2.0 SITE CHARACTERISTICS

Chapter 2, "Site Characteristics," of the Turkey Point Units 6 and 7 combined license (COL) final safety analysis report (FSAR) addresses the geological, seismological, hydrological, and meteorological characteristics of the Turkey Point Units 6 and 7 site and vicinity, in conjunction with present and projected population distribution and land use and site activities and controls.

2.0.2 Summary of Application

Figure 2.4.12-1. Simulated piezometric levels across the plant area (Layer 1-4 correspond to the four layers: Miami Limestone, Key Largo Limestone, Freshwater Limestone, and Fort Thompson Formation in the numerical model).

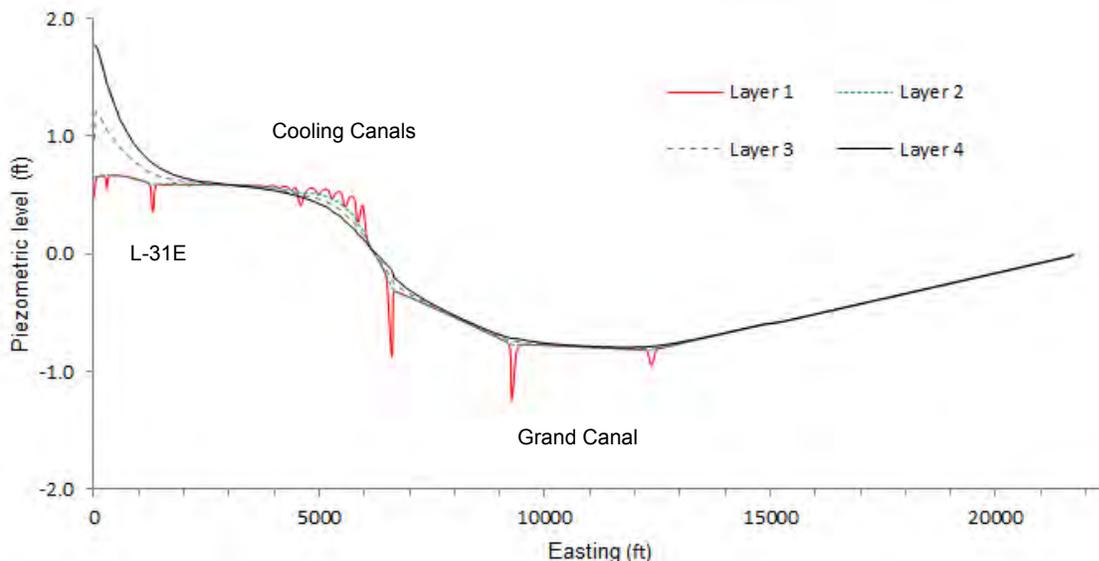
To assess the influence of water use in the plant on the regional groundwater flow directions, the staff took an east-west cross section from the applicant's 3-dimensional groundwater model grid (row 260, east-west across the plant) and constructed a 2-dimensional groundwater model using a publicly available spreadsheet tool (Anderson and Bair 2001). The boundary conditions in the east and west were modeled as fixed head boundaries. The results (Figure 2.4.12-1) confirm that the regional hydraulic gradient from the west (inland) to the east (ocean) is controlled by the water levels in the cooling and L-31E irrigation canals. The vertical gradient is even smaller and the variations near the canals are significant only in the first layer (Miami Limestone) and dampen out with depth in the underlying layers 2–4 (Key Largo Limestone, freshwater limestone, and Fort Thompson Formation, respectively). These results show that as long as the water level in the canals is maintained at the designed level, water use at the plant is not expected to alter the regional groundwater flow direction (from the west to the east, and from underground to the ground surface). This is due to the relatively permeable subsurface geologic formations and small hydraulic gradient at the site.

The staff performed an independent confirmatory analysis of the potential impact of the maximum water level of 22.5 ft (6.9 m) in the MWR on the subsurface potentiometric head distribution at Turkey Point Units 6 and 7, as described below. The staff calculated the lateral head losses from the MWR through the 3 ft (0.9 m) thick concrete floor and then through 100 ft of the Miami Limestone aquifer. According to Darcy's law, discharge rate, q , is estimated as $q = k_1 \Delta h_1 / L_1 = k_2 \Delta h_2 / L_2$, and $\Delta h = \Delta h_1 + \Delta h_2$, where k , Δh , and L are the hydraulic conductivity, head loss, and length, and subscripts 1 and 2 stand for the concrete layer and aquifer layer, respectively. It can be derived that $\Delta h_1 / \Delta h = (L_1 / k_1) / (L_1 / k_1 + L_2 / k_2)$. Using conservative values for k_1 and k_2 , i.e., $k_1 = 10^{-8}$ cm/s (Turkey Point Units 6 and 7 COL FSAR 2.4.13.1.3.1 assumes 8.25×10^{-9} cm/s, which is an order of magnitude higher than that of intact concrete in included reference) and $k_2 = 10^{-4}$ cm/s (less than the smallest calibrated value in Turkey Point Units 6 and 7 COL FSAR Table 2CC-205), the calculated head loss in the concrete floor is 22.4 ft (6.8 m). This result indicates that most of the head is expected to be lost over the concrete floor of the MWR due to its low permeability. Therefore, the water in the MWR, even at maximum level, is not expected to raise the groundwater table under Turkey Point Units 6 and 7 significantly (less than a few feet, comparing with the 23.5 ft (7.2 m) design elevation). Accordingly, the staff's review of the studies and reports described above and the staff's evaluation of the applicant's analysis described above confirmed that the applicant's description of the groundwater flow directions is acceptable and adequate.

Figure 2.4.12-2. Maximum groundwater mounding under steady-state flow condition with aquifer thickness of 25 ft (7.6 m) (freshwater limestone as the aquitard).

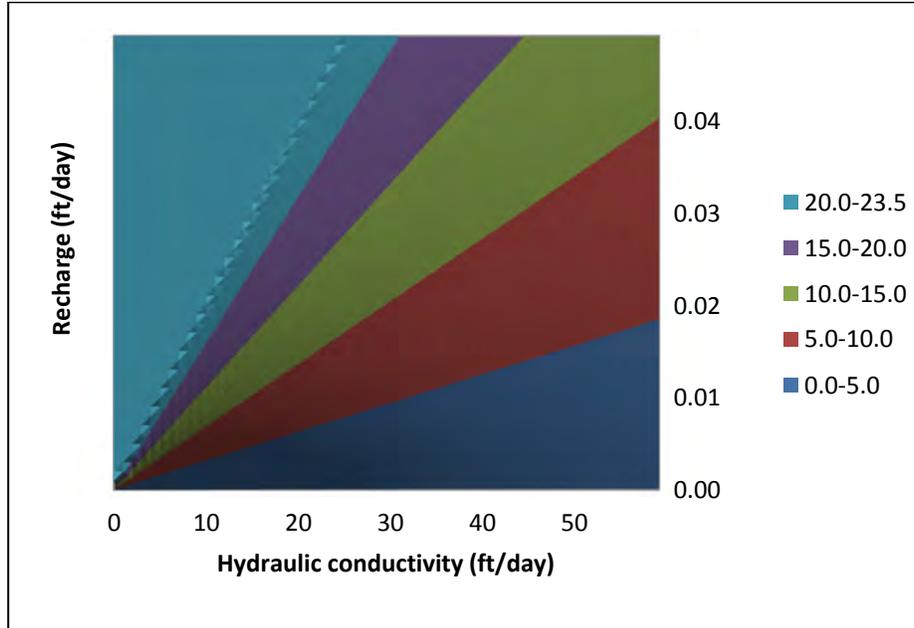
Let $R = 1,330$ ft (405 m), and h_{max} is dependent on the hydraulic conductivity, recharge rate, and aquifer thickness. A hydraulic conductivity of less than 3-4 ft/day (0.9-1.2 m/day) is necessary for the mounding to be over the 23.5 ft (7.2 m) maximum groundwater level (Figure 2.4.12-2) with a recharge equal to the annual precipitation $w = 3.79$ ft/year = 0.01 ft/day and an assumed aquifer thickness of 25 ft (freshwater limestone as the aquitard). As the vertical hydraulic conductivity of the surficial Biscayne aquifer is approximately 15 ft/day (4.6 m/day) (Turkey Point Units 6 and 7

COL FSAR Revision 2, Table 2.4.12-205), the maximum water level is not likely to be exceeded under steady-state flow conditions, given expected conductivity of the fill material used to build up the island. Accordingly, the staff finds that that the maximum groundwater level meets the criteria of the Design Control Document (DCD) of the AP1000 at a maximum of 2 ft (0.6 m) below grade.

Figure 2.4.12-3. Groundwater mounding calculated using Basak (1982) for the 72-hour probable maximum precipitation of 55.7 in.

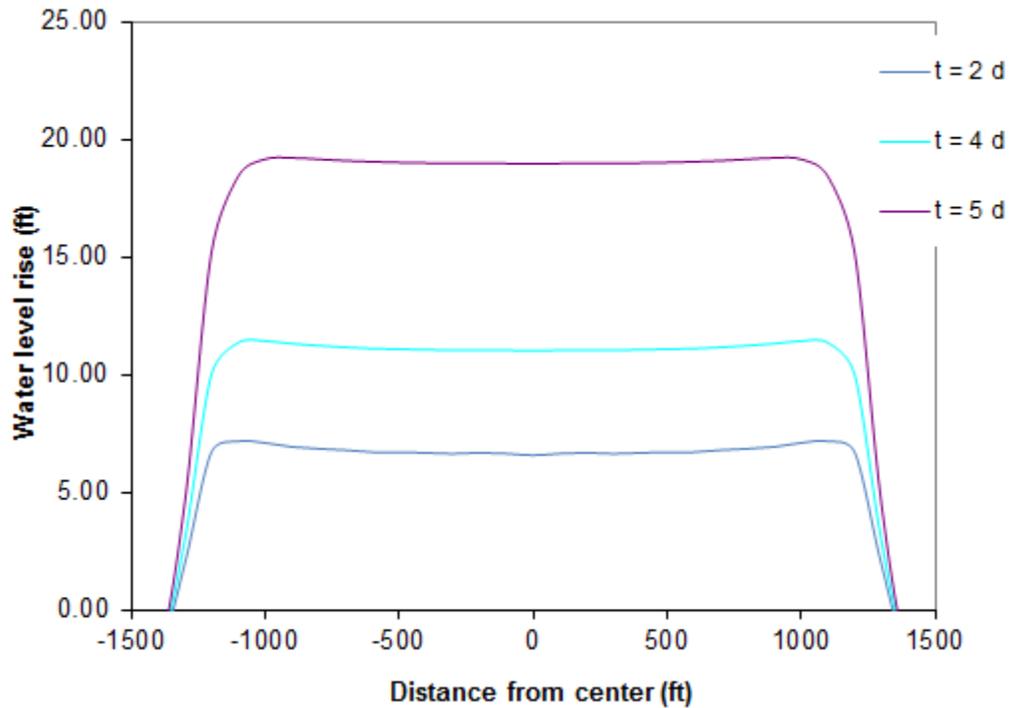
The staff also estimated maximum groundwater elevation under a transient flow scenario. The 72-hour probable maximum precipitation of 55.7 in. for areas of 10 mi² or less in the Florida peninsula was considered. The approximate analytical solution by Basak (1982) was used to calculate the groundwater table mounding. The results (Figure 2.4.12-3) show that the maximum water level of 23.5 ft (7.2 m) is not likely to be exceeded, even when the maximum precipitation occurs for 5 days ($R = 1,330$ ft (405 m), $k = 15$ ft/day (4.6 ft/day), $b_0 = 50$ ft (15.2 m), and specific yield = 0.3). Even though the Basak (1982) solution is accurate only for a small mounding level (say 5 ft (1.5 m) of a 25 ft (7.6 m) thick unconfined island aquifer) and for a hydraulic conductivity greater than the recharge rate, the possible maximum mounding level would be expected to be much less than 23.5 ft (7.2 m) for an expected recharge rate less than 1 ft/day, and hydraulic conductivity greater than 10 ft/day (Figure 2.4.12-4). Accordingly, the staff finds that that the maximum groundwater level under a transient flow scenario meets the criteria of the Design Control Document (DCD) of the AP1000 at a maximum of 2 ft (0.6 m) below grade.

design level. In the staff's analysis, no coverage of ground surface with pavement was assumed. The results of the staff analysis confirmed that the extent of pavement did not influence groundwater mounding

Figure 2.5.1-9. Cunningham (2015) Seismic Sag structure

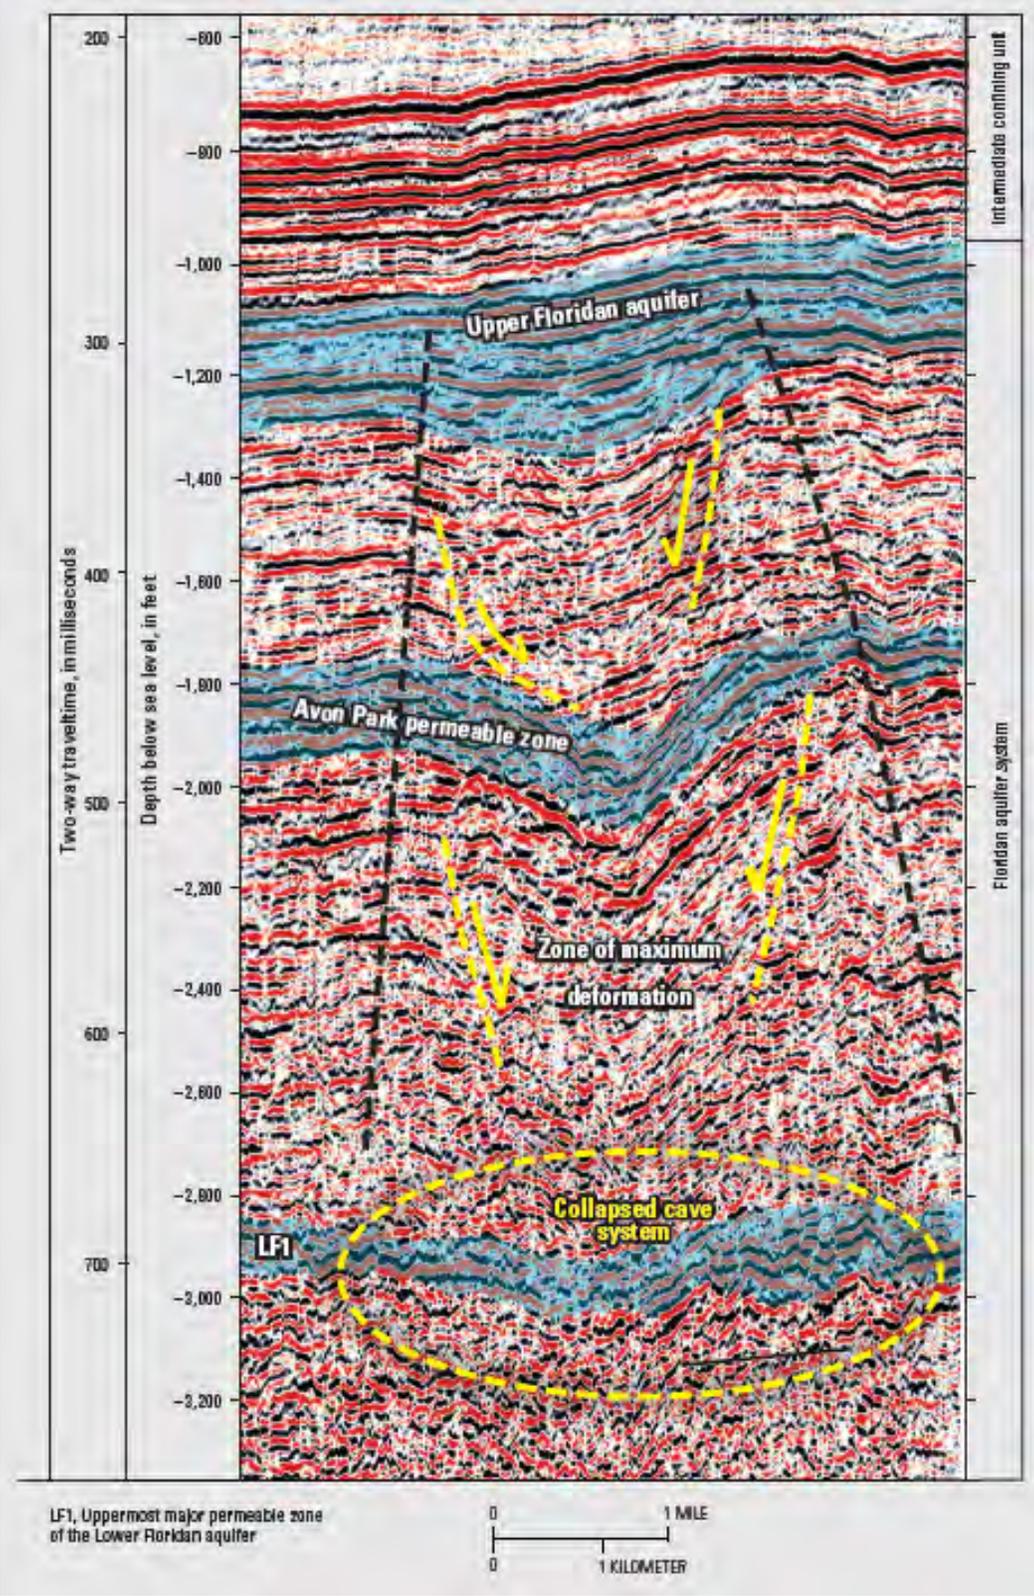
The applicant proposed to include portions of the response to RAI 41, Question 02.05.01-4, in a future revision of the Turkey Point Units 6 and 7 COL FSAR. The staff finds the proposed revisions acceptable and has confirmed that these changes have been incorporated into the Turkey Point Units 6 and 7 COL FSAR.

Figure 2.5.1-10. Strike-slip fault (unnamed) in Biscayne Bay (Source: Turkey Point Units 6 and 7 FSAR Figure 2.5.1-393, Cunningham et al., 2012 and Cunningham, 2015).

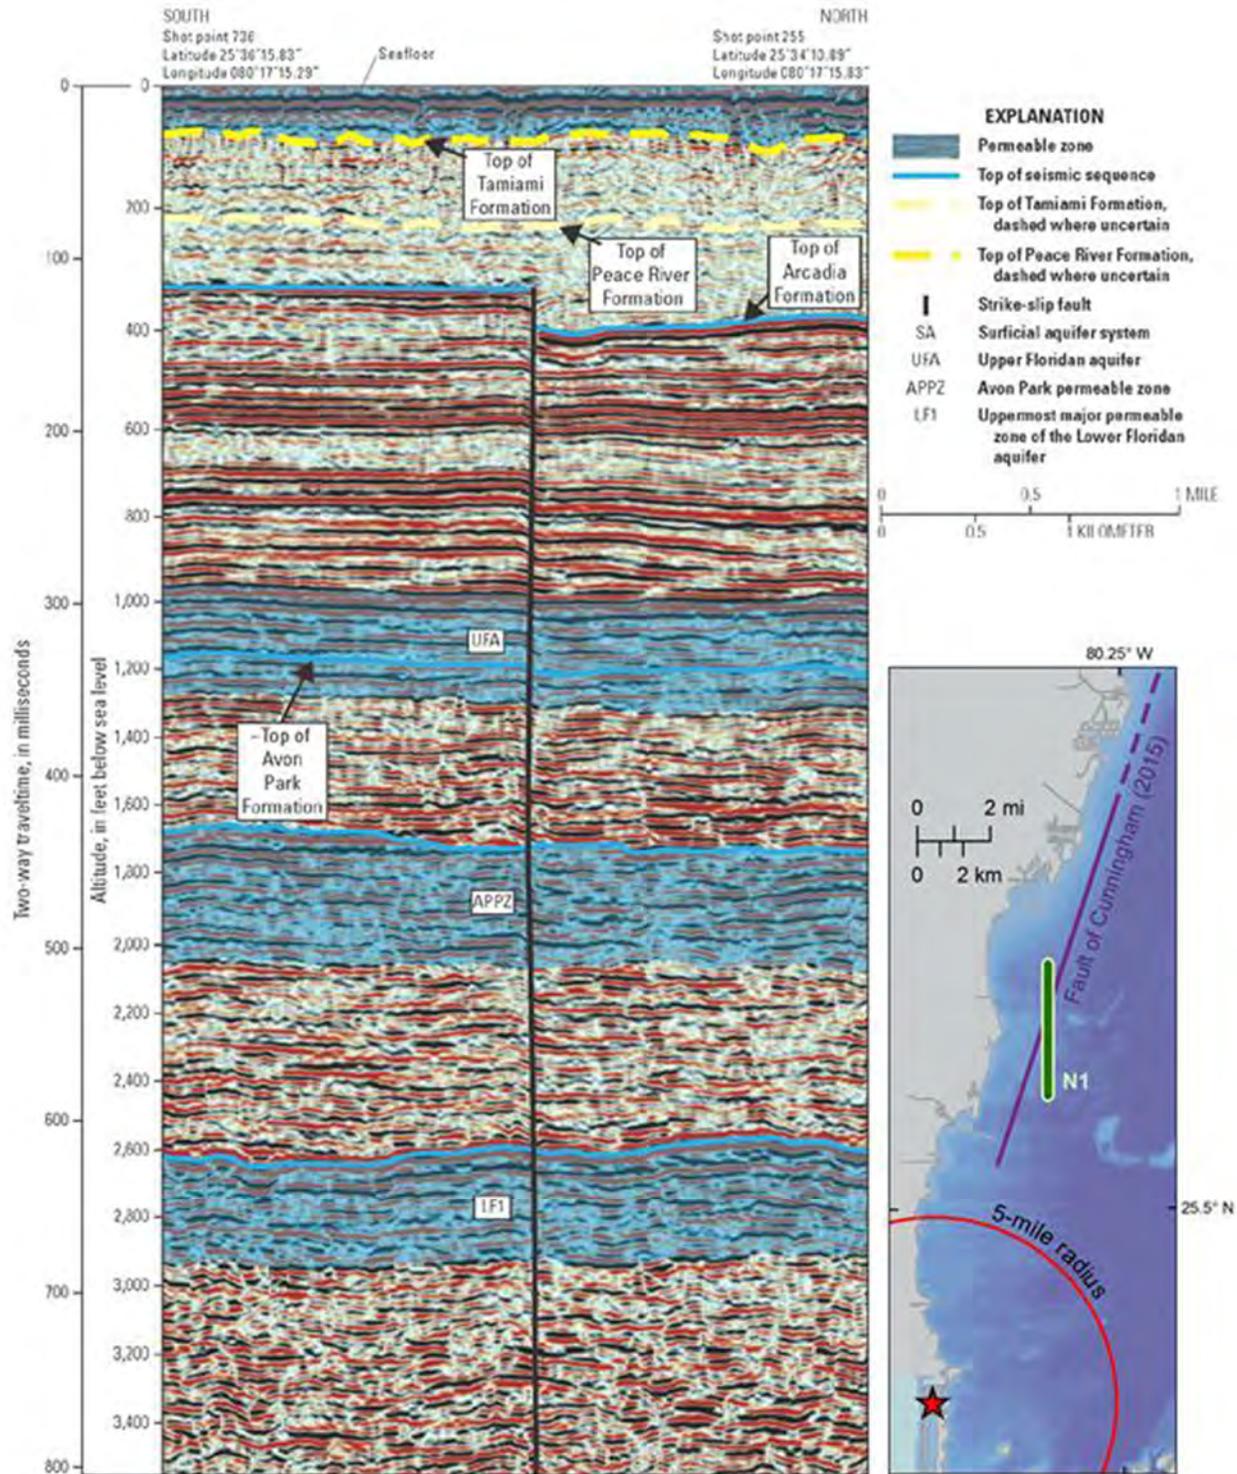
The staff independently sought out and reviewed many publications pertaining to the Turkey Point Units 6 and 7 COL FSAR review and found a recent short paper (Cunningham et al., 2012) that reveals normal and reverse faults in Biscayne Bay and the shelf margin, within 11.3 km (7 mi) of the site, based on approximately 210 km (130 mi) of high-resolution marine seismic data. One of these faults is identified on 5 seismic lines and extends about 16 km (10 mi), striking N, NE (Figure 2.5.1-10). The authors interpret this fault as a vertical normal fault offsetting the top of the Arcadia Formation. The staff notes that the fault projects directly toward the Turkey Point Units 6 and 7 site. Because the fault appears to offset the top of the Arcadia Formation, the age of movement might be as young as early Pliocene (5.3 Ma). The staff also notes that this tectonic structure is not included in the Turkey Point Units 6 and 7 COL FSAR. In RAI 81, Question 02.05.01-36, the staff asked the applicant to discuss this tectonic feature with respect to the Turkey Point Units 6 and 7 site, and integrate the information into the regional tectonic setting. The staff also asked the applicant to address the possibility that the fault is strike-slip and finally to address the possibility that this fault underlies the Turkey Point Units 6 and 7 site, and what impact if any does this have on potential surface deformation.

In a May 19, 2015, response to RAI 81, Question 02.05.01-36 (ADAMS Accession No. ML15156A616), the applicant cited a recent USGS Scientific Investigations Report (Cunningham, 2015) that includes additional information about the fault identified in Biscayne Bay. Cunningham (2015) extends the fault, as uncertain, an additional 30 km (20 mi) northward through a data gap to connect with a possible offset identified in seismic profiles at the Miami-Dade North District Boulder Zone Water Field. Cunningham (2015) now interprets this fault as strike-slip with a characteristic normal, dip-slip component (up to the east), with typically about 12 m (40 ft) of vertical separation. The youngest faulted strata are the Arcadia Formation (Miocene age). The author interprets the top of Peace River and Tamiami formation (Pliocene) strata as unfaulted. Movement on the fault is thus interpreted to be within mid Miocene to early Pliocene, meaning no movement in the last 3.6 Ma.

Figure 2.5.1-11. Miami Terrace anticline from Cunningham, 2015 (Source: Turkey Point Units 6 and 7 COL FSAR Figure 2.5.1-395)

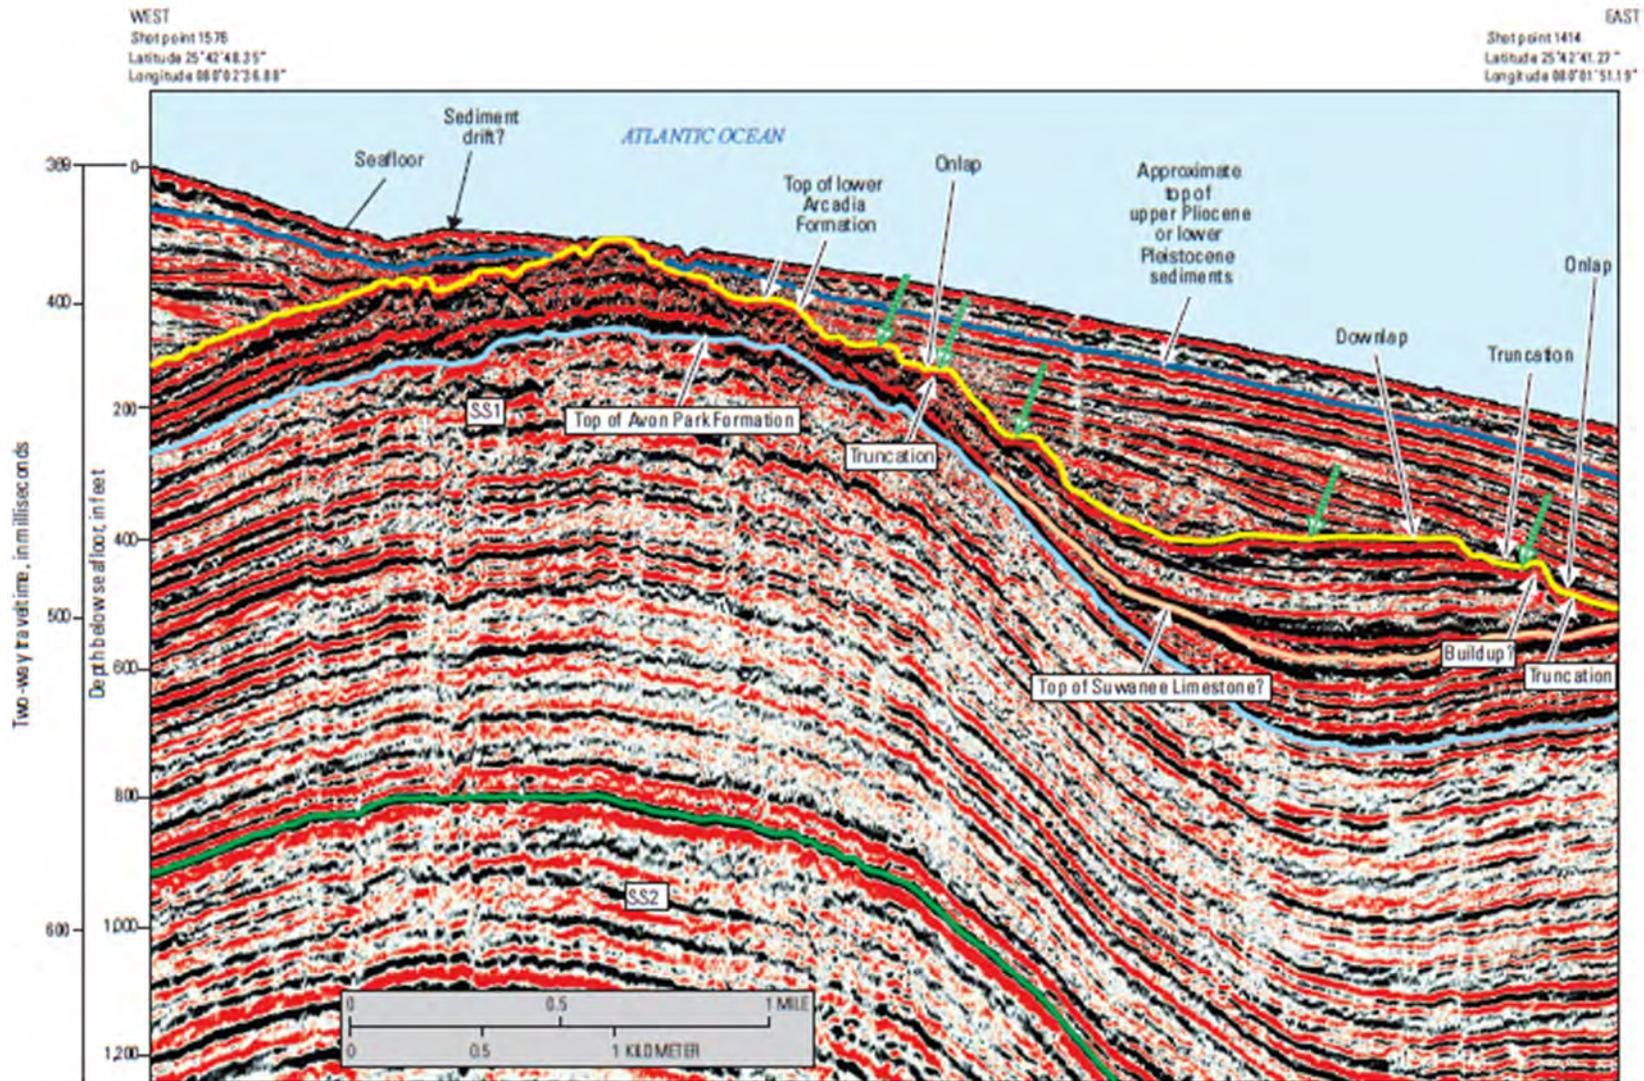
The staff independently reviewed Cunningham (2015) and observed a tectonic anticline, located east of Miami, on the Miami Terrace, about 48.2 km (30 mi) from the Turkey Point Units 6 and 7 site that has not been previously discussed in the Turkey Point Units 6 and 7 COL FSAR. Cunningham (2015) clearly shows a tectonic anticline with uplifted truncated seismic reflections assigned to the top of the lower Arcadia Formation (Figure 2.5.1-11). Horizontal, buried wave-cut terraces on the flank of the anticline indicate uplift and erosion of the lower Arcadia Formation followed by deposition of late Pliocene or early Pleistocene-age sediments. The author suggests that this compression event is consistent with the timing of tectonic movement of the Santaren anticline, also considered a potential Quaternary structure. The staff also notes that this young tectonic structure is close to the Turkey Point Units 6 and 7 site and has not been previously characterized in the Turkey Point Units 6 and 7 COL FSAR. Therefore, in RAI 85, Question 02.05.01-38, the staff asked the applicant to discuss this tectonic feature with respect to the Turkey Point Units 6 and 7 site, to integrate the feature into the regional tectonic setting for the Turkey Point Units 6 and 7 site COLA, and, finally, to discuss how this feature might affect the PSHA at the Turkey Point Units 6 and 7 site in light of sensitivity analyses completed for the Santaren Anticline and the Walker's Cay fault, 274 and 320 km (170 and 200 mi) from the Turkey Point Units 6 and 7 site, respectively.

In addressing the staff's question regarding the Miami Terrace structures' effect on the Turkey Point Units 6 and 7 site's PSHA (RAI 85, Question 02.05.01-38), the applicant cited Appendix A to RG 1.208 definition of a capable tectonic source and stated that because the uppermost deformed strata observed in the anticline and reverse faults is the Oligocene to Miocene Arcadia Formation, the structures are not considered to be capable tectonic features. The applicant pointed out that there is only one Emb 2.70 earthquake in the project Phase 1 earthquake catalog, including dependent events, located approximately 10 km away from the Miami terrace structures. Thus, there does not appear to be an association of seismicity with these structures. Therefore, the applicant stated that the reverse faults and fold reported by Cunningham et al. (2012) and Cunningham (2015) are not capable tectonic sources and would not affect, and should not be included in, the PSHA for the Turkey Point Units 6 and 7 site.

Figure 2.5.1-12. Santaren anticline and faults from Jo et al., 2015.

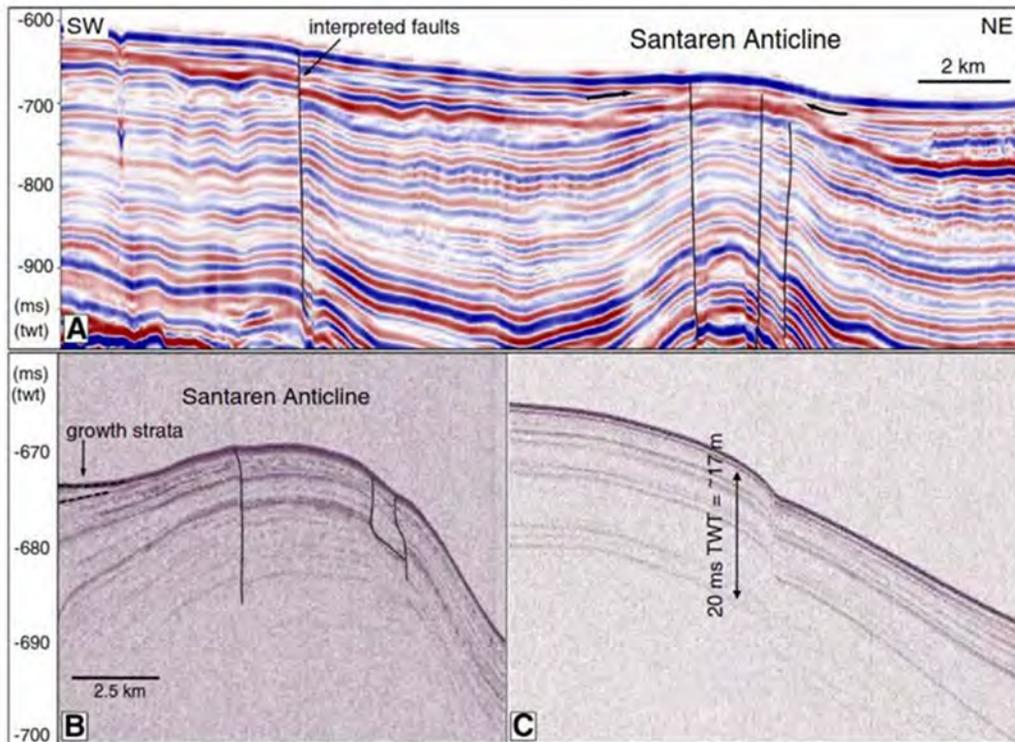
The applicant stated that while a fault has yet to be imaged in the core of the relatively symmetrical Santaren anticline, this structure is a candidate for a potential seismic source because fold deformation appears to be Quaternary in age (Jo, 2013; Jo et al., 2015) and a fold uplift rate was determined for this structure (Masferro et al., 2002). New high-resolution seismic data and subbottom profiles illustrate Quaternary growth strata and steeply dipping secondary faults associated with the Santaren anticline, further suggesting ongoing deformation of the anticline (Jo et al., 2015) (Figure 2.5.1- 12).
